Bayside Planning Panel

Item No	6.1
Application Type	Modification to Submission
Application No	DA-2016/402/A
Lodgement Date	18/09/2017
Property	686 and 688 Princes Highway, Kogarah
Ward	Bexley
Owner	Tonuja Constructions Pty Ltd
Applicant	Tonuja Constructions Pty Ltd
Proposal	Modification application to delete condition number 11A, 11B, 31, and 51 relating to loading bay, location of services and swept paths. Original application approved the construction of a four (4) storey residential flat building comprising sixteen (16) residential units, rooftop terrace, basement parking and demolition of existing structures.
No. of Submissions	Nil.
Cost of Development	N/A
Report by	Marta Gonzalez-Valdes, Coordinator Major Assessments

Planning Assessment Report

Application Number:	DA-2016/402/A
Date of Lodgement:	18 September 2017
Property:	686 and 688 Princes Highway, KOGARAH NSW 2217 Lot 2 DP 1188540
Owner:	Tonuja Constructions Pty Ltd
Applicant:	Tonuja Constructions Pty Ltd
Proposal:	Modification application to delete condition number 11A, 11B, 31, and 51 relating to loading bay, location of services and swept paths. Original application approved the construction of a four (4) storey resi

Figure 1 - Updated Landscape Plan, illustrating the presence of Loading Dock on the northern portion of the Cross Lane frontage.

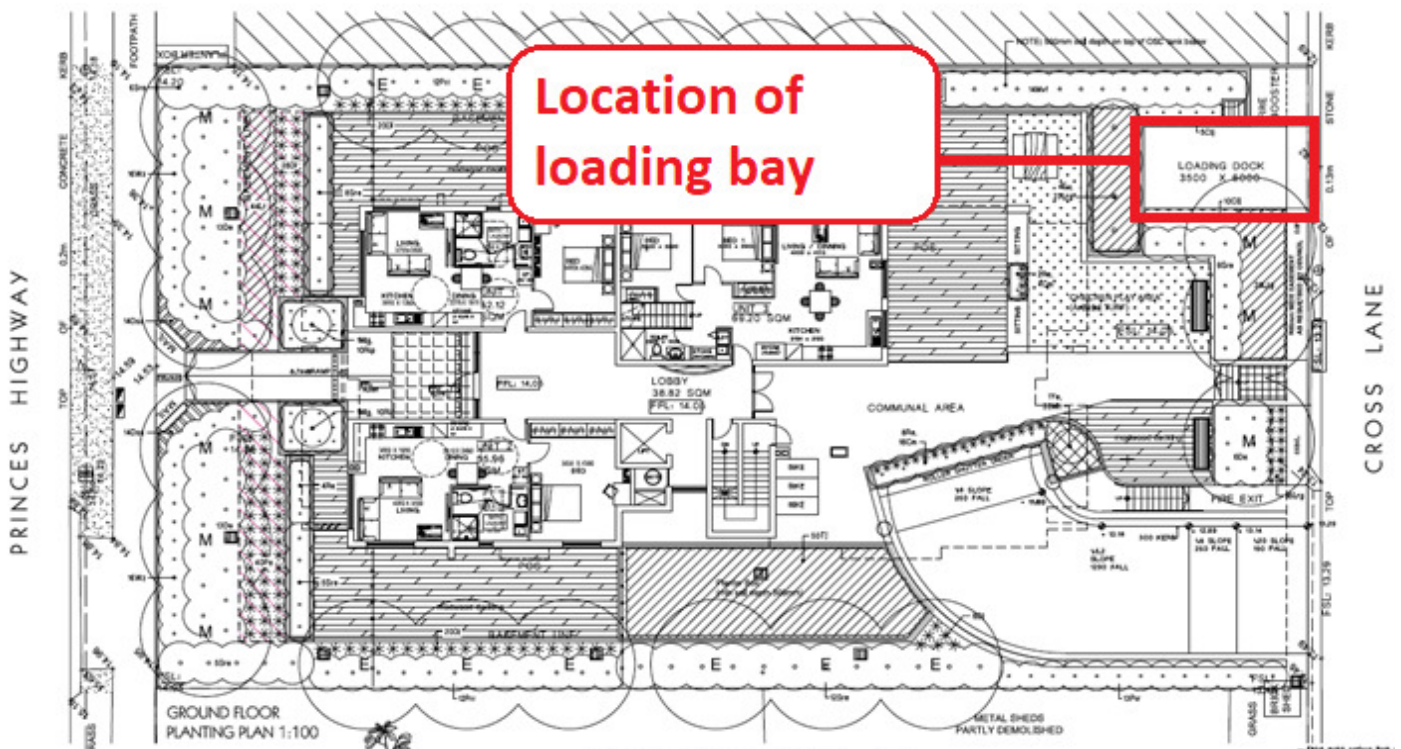
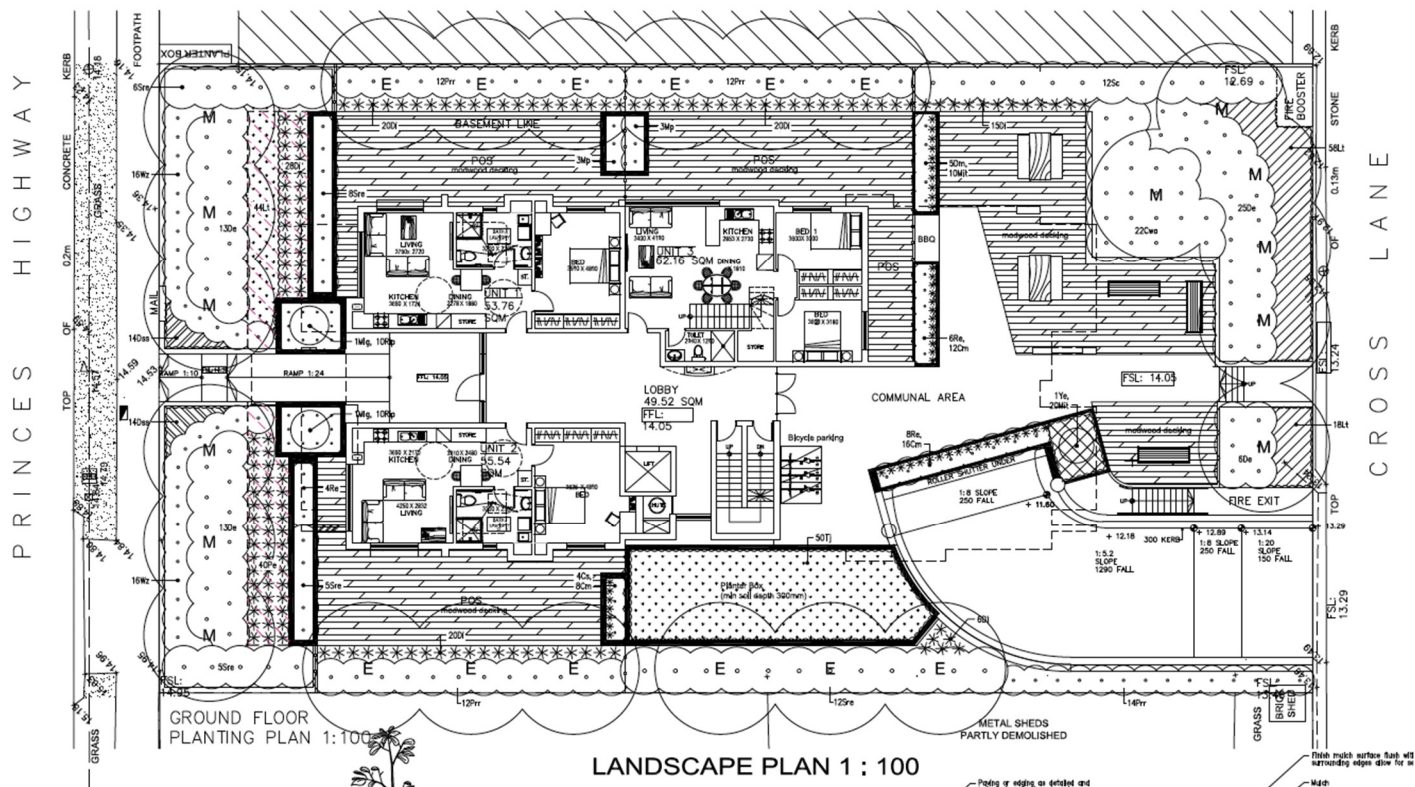
Comment: The subject modification seeks to locate the loading bay separately from the driveway on Cross Lane.

Council's Traffic Engineer further confirmed that a loading bay is required for the proposal and if it were located away from the driveway the surface of the loading bay could be made to be permeable. The modification seeks to locate the loading bay on the northern end of the Cross Lane frontage.

Figure 4 - Proposed location of the loading bay as framed by landscape treatment

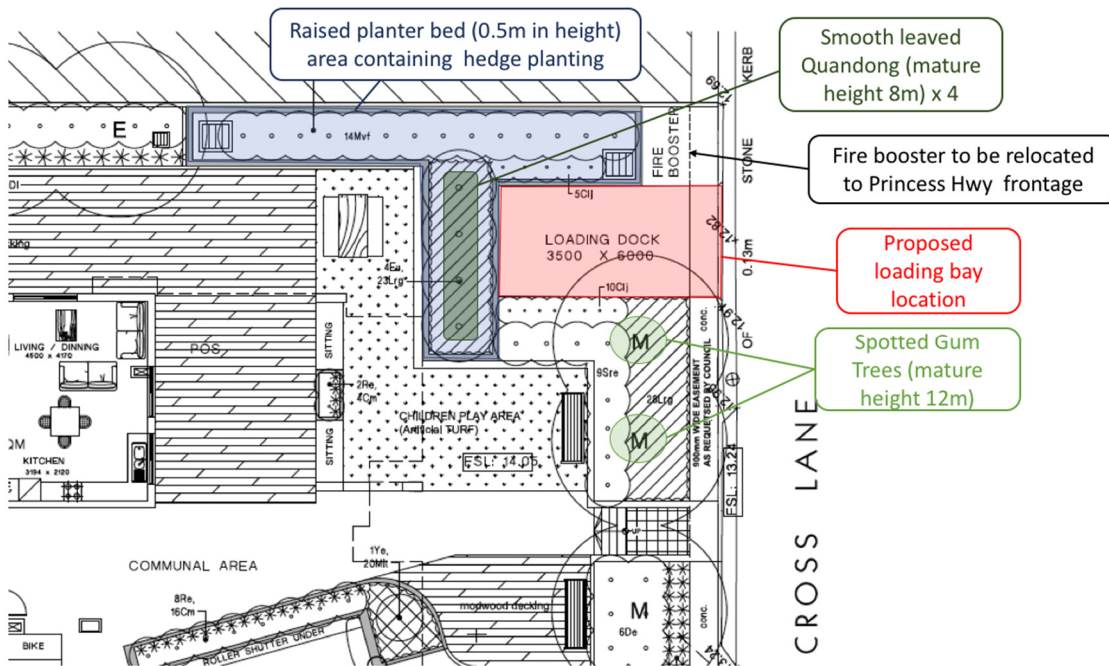
The accompanying Landscape Plan, prepared by Ray Fuggle + Associates, illustrates that the visual appearance of proposed location of the loading bay, when viewing from Cross Lane, is improved by landscape treatments. These treatments include:

- Framing the rear and northern side boundary of the loading bay with 0.5m high planter beds containing *Metrosideros vitiensis* (Fiji Fire) hedge plantings;
- Anchored the southern boundary of the loading bay with 2 x Spotted Gum tree plantings, which would serve as a greater focal point along this frontage;
- The fire booster (identified as adjoining the loading bay on the Landscape Plan) will need to be relocated to Princes Hwy to comply with Fire and Rescue NSW requirements, and will be required to be replaced by landscaping.

The area nominated as Fire Booster on the approved (updated) Landscape Plan will require landscape treatment commensurate to the treatment provided immediately adjoining along the adjoining northern boundary.

Noting the above, the proposed landscaping ensures that the loading bay will not become a focal point of this frontage and ensures that the development continues to set a high level for landscape character in Cross Lane, which future development will need to consider.

- To ensure consistency with the landscape plan.
- 11D. The surface of the proposed loading bay is required to be permeable as to allow water filtration into the soil.
[Amendment A - S96(1A) inserted on 22 May 2018]
Reason for additional condition 11D is:

issue:	CC	date:	29/08/17	issue no:	C
file name:	c:\			drawing No:	
drawn:	HK	scale:	1:100 @ A1		
checked:	RF	project No:	4016c		L-01

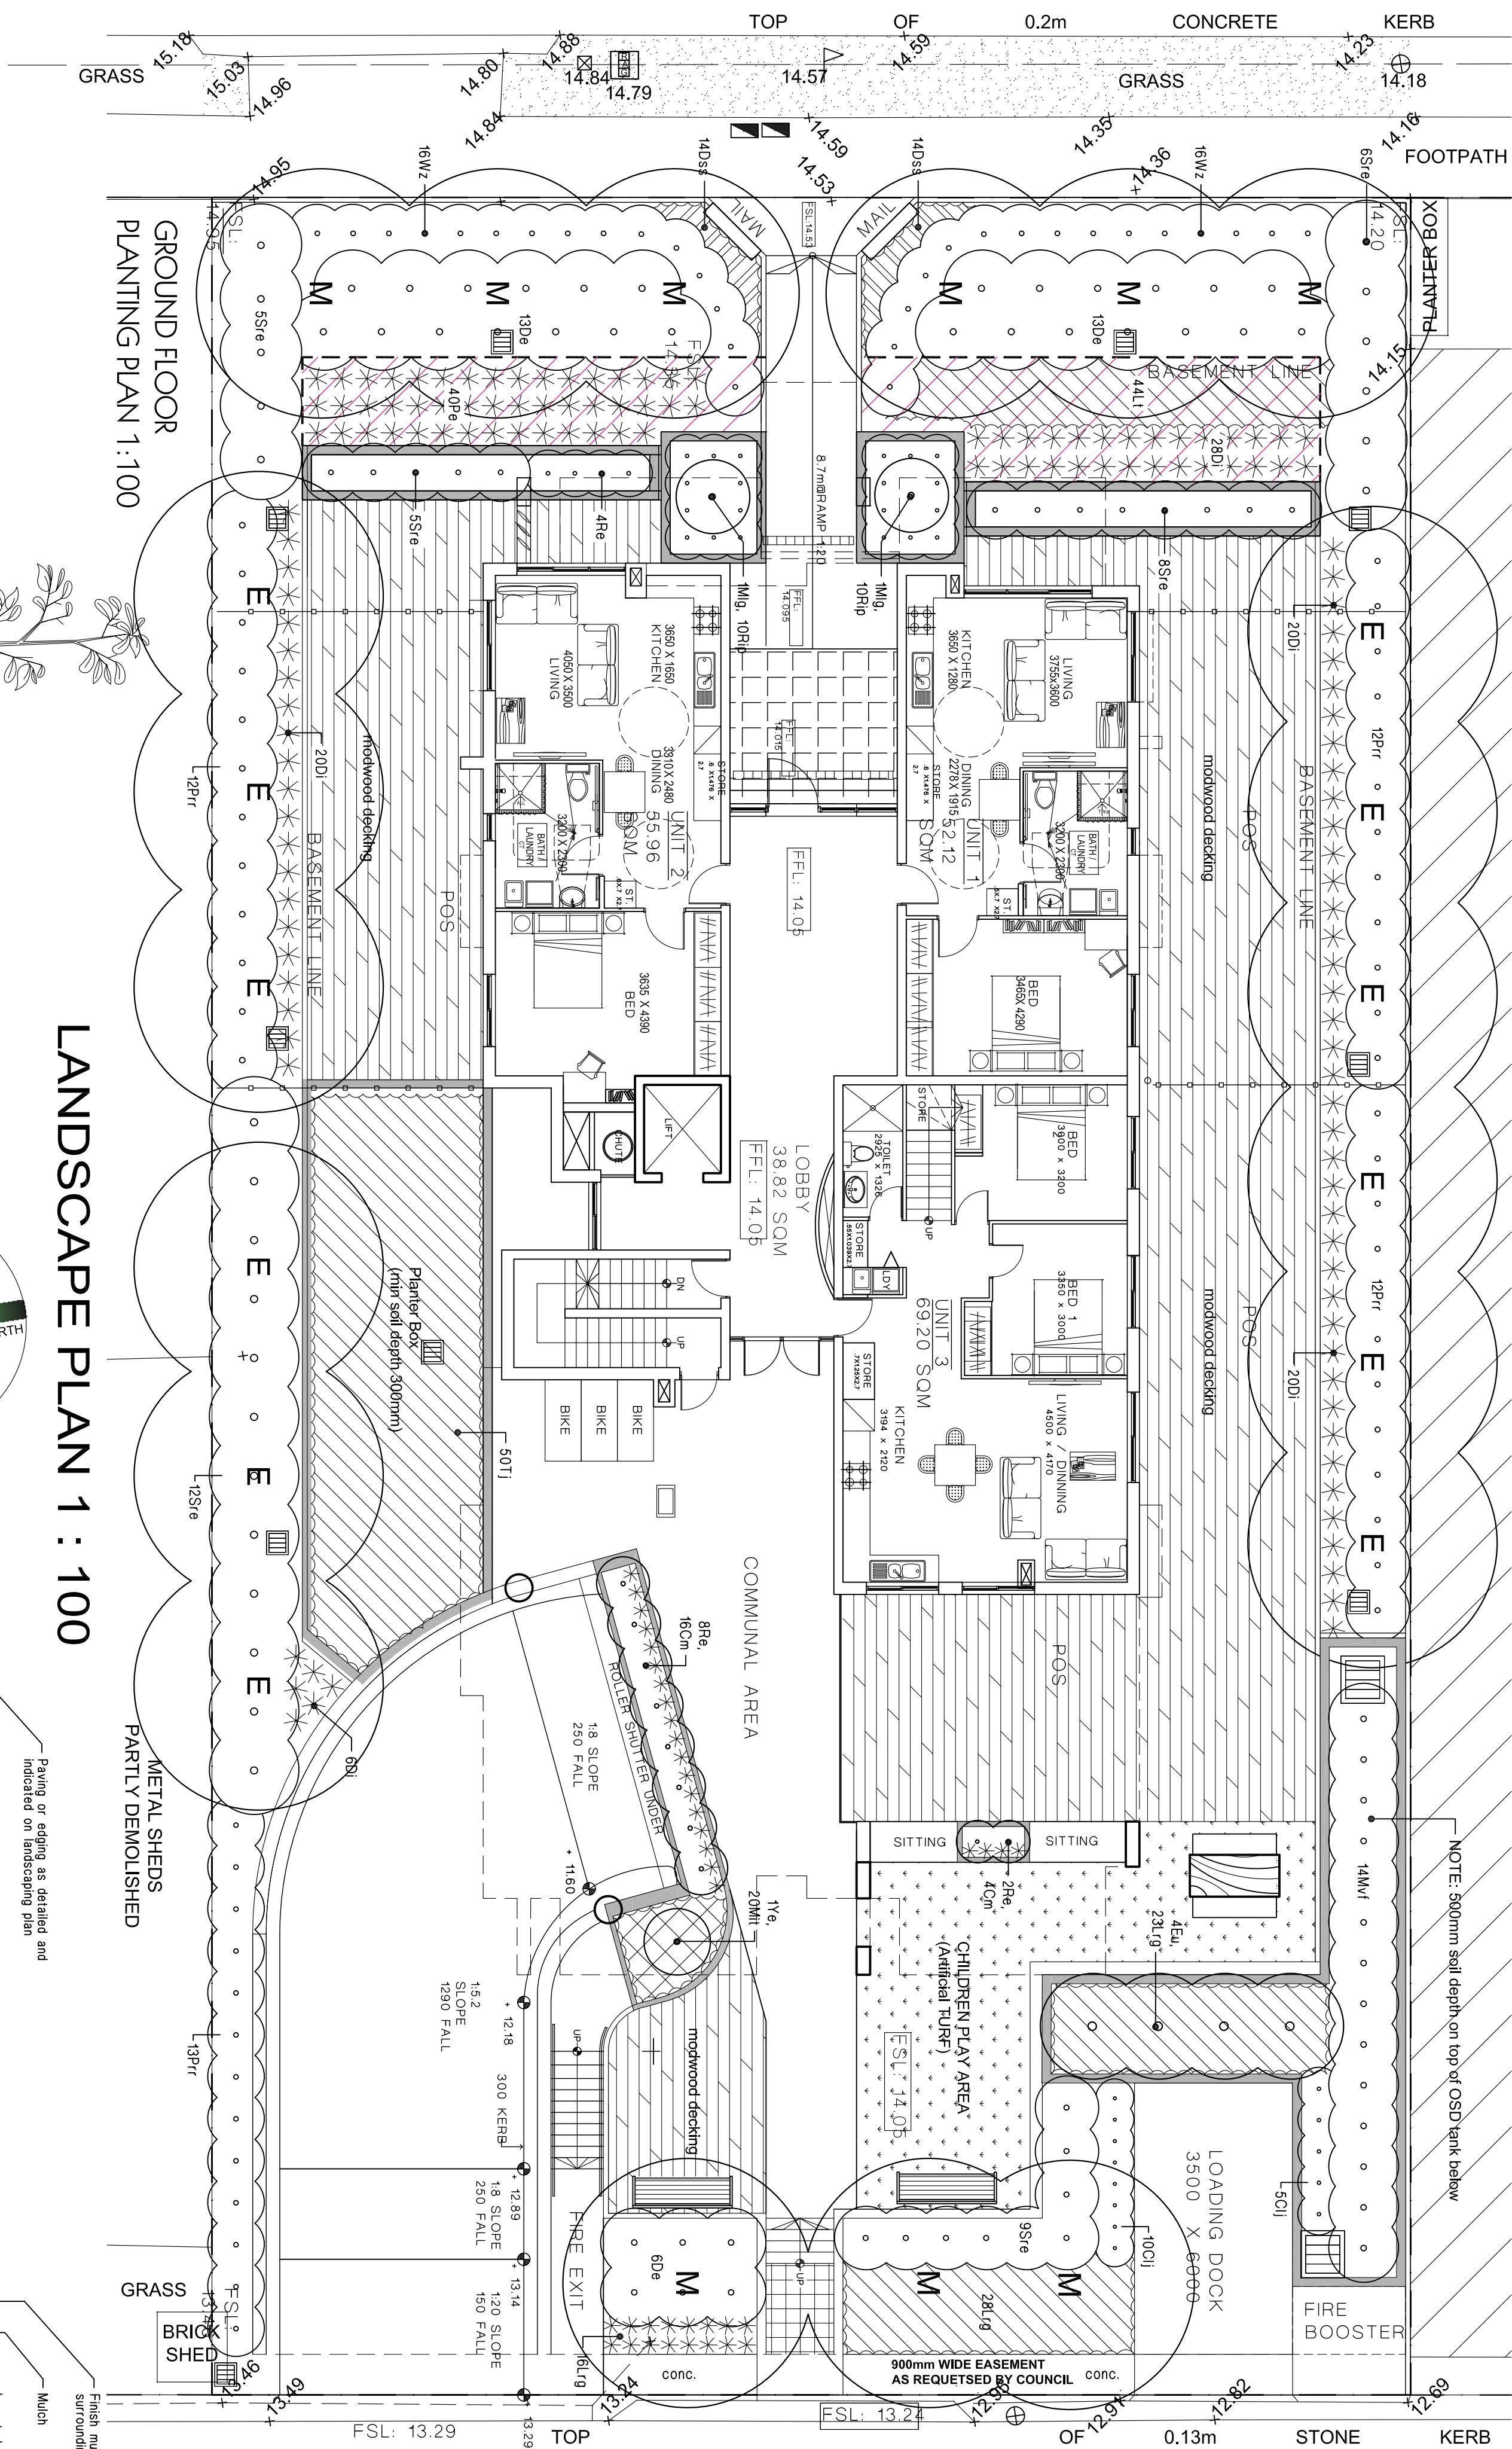
1. The loading bay off Cross Lane has appropriate screen planting, looking from the private open space, BBQ area and children play area, and from adjoining northern neighbour (closer to the loading bay).
2. Condition 11. Rooftop terrace includes a 1.5m wide non trafficable area, dedicated to screen planting. The setbacks include trees and shrubs to provide screen planting to the development and to adjoining properties. Some embellishment treatment had been added to the communal undercroft, although not all detailed in the landscape plan.
3. Condition 11.A. The loading zone off Cross lane is present on the proposal, to provide access to Fire Booster, (Condition 31).
4. Condition 11.B. The retaining of the loading bay annulated condition 11B. Loading bay should be treated with a permeable surface, to enhance water filtration in deep soil zone.

- 11B. *[Amendment A - S96(1A) deleted on 22 May 2018]*
- 11C. The area nominated as Fire Booster on the approved (updated) Landscape Plan will require landscape treatment commensurate to the treatment provided immediately adjoining along the adjoining northern boundary.
[Amendment A - S96(1A) inserted on 22 May 2018]
Reason for additional condition 11C is:
